SAFETY EVALUATION
BY THE OFFICE OF NUCLEAR MATERIAL SAFETY AND SAFEGUARDS
RELATED TO AMENDMENT NO. 302
TO FACILITY OPERATING LICENSE NO. DPR-40
OMAHA PUBLIC POWER DISTRICT
FORT CALHOUN STATION, UNIT 1
DOCKET NO. 50-285

Date
January 31, 2024

Figure 6-1: Strontium-90 Results in Groundwater. Wells in the Legend Are Ordered from Plant-North Clockwise to Plant-Northwest Outside the Deconstruction Area.

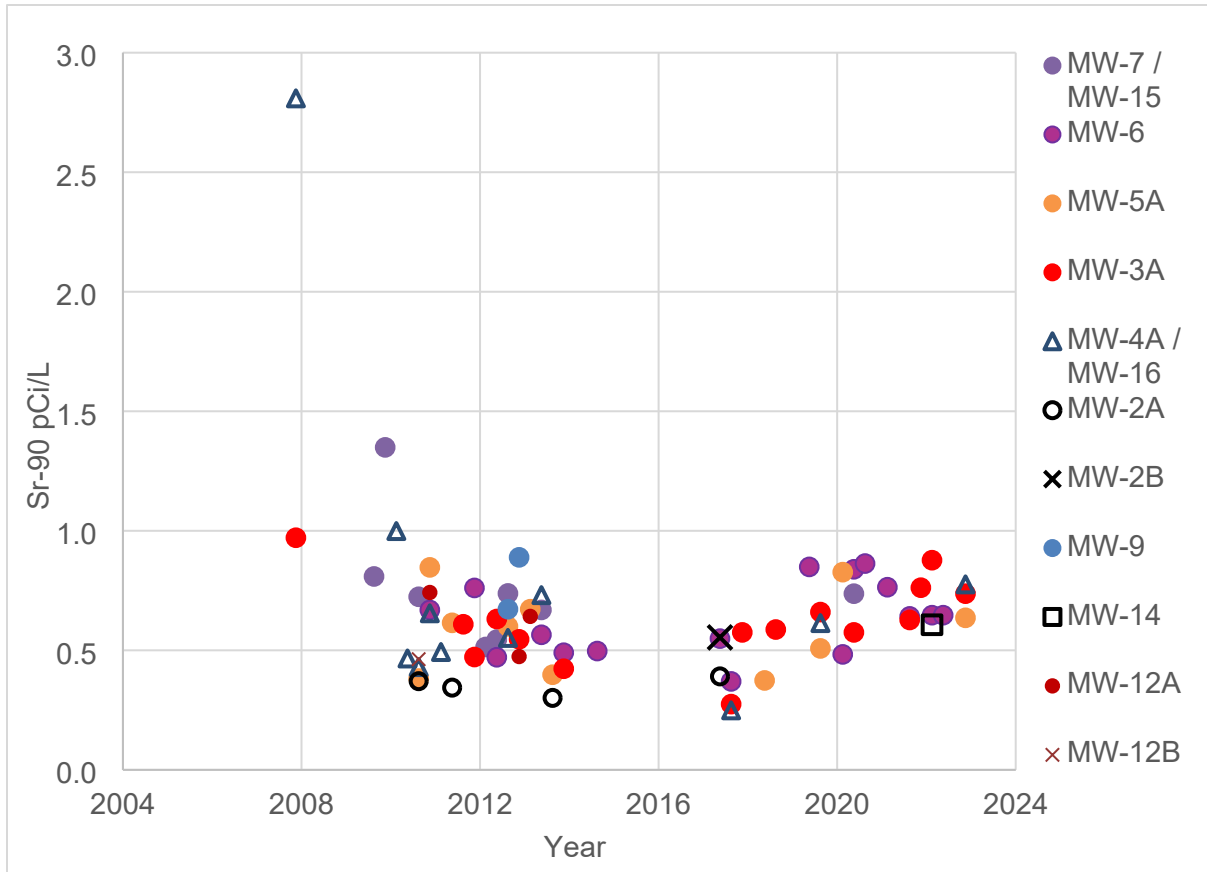
Figure 6-1 illustrates the range of Sr-90 values and distribution over time for monitoring wells for results above LLD. A notable feature in Figure 6-1 is the gap in positive Sr-90 results in 2015 and 2016. This is a period when peak river levels in spring and summer were lower than for other years, though there are other years with low peak river stages. Another notable feature is the decrease in the number of positive Sr-90 results for the periods from 2010-2014 and 2017-2021. Staff notes, however, that the decrease may be misleading due to the evolving sampling strategy over time. Specifically, the total number of samples analyzed decreased between the two periods by more than half, but the percentage of Sr-90 results above LLD significantly increased for the later period. To illustrate this point further, there were eight instances when the only measurement made at a well during a year resulted in a Sr-90 value above LLD during the period 2017-2021, whereas there were none during the 2010-2014 period. Therefore, staff cannot discount the possibility that the trend in the number of occurrences of Sr-90 above LLD is caused by the change in sampling strategy rather than a decreased presence of Sr-90 in groundwater. The year with the highest percentage of Sr-90 results is 2020 when 46 percent of the samples were above LLD compared to the period 2010 through 2014 when 22 percent were above LLD. Whereas this increased percentage could reflect an improved sampling strategy, the change in strategy may have also missed possible measurement events exhibiting Sr-90 in the groundwater. Therefore, the number of wells with non-zero Sr-90 levels each quarter or each year should not be compared with other quarters or years.

Based on the Sr-90 observations, staff cannot discount the possibility of a persistent source in the Deconstruction Area of unknown location and magnitude. In SER section 6.12.8, staff noted at least one HSA incident where spent fuel pool water leaked to the environment; spent fuel pool water could contain Sr-90. Staff notes that the spatial and temporal pattern of Sr-90 results appears to be consistent with a contaminated source area in the unsaturated zone that is activated during higher river stages. Staff notes that the percentage of positive Sr-90 results is inversely correlated with the seasonal river stage. The licensee set sampling cycles to quarterly for the purpose of capturing the seasonal changes. Staff notes that quarters 2 and 3 are periods of high river stage, and these are the quarters with the highest percentage of Sr-90 results above LLD. Spatially, more of the positive Sr-90 results (above LLD) occur at wells closest to the facility with occurrences on all sides. Consistent with the bank storage conceptual site model, the residual radioactivity would migrate in different directions dependent on prior river stage level. Prior to 2018, groundwater directions were also influenced by onsite pumping and influx into the Turbine Building related to broken drain lines (see SER sections 6.12.5 and 6.12.8). During the pre-2018 period, staff assessment of the historical groundwater data indicated gradients approximately equally divided between plant-west (inland), mounded under the site, and plant-east (towards the river). Post-2018, the groundwater gradient direction was more often towards the river. Staff analysis indicated that wells closest to the buildings and furthest from the influence of the pre-2018 pumping well are the wells with the most positive Sr-90 results. Since the groundwater directions varied due to pumping and to changes in river
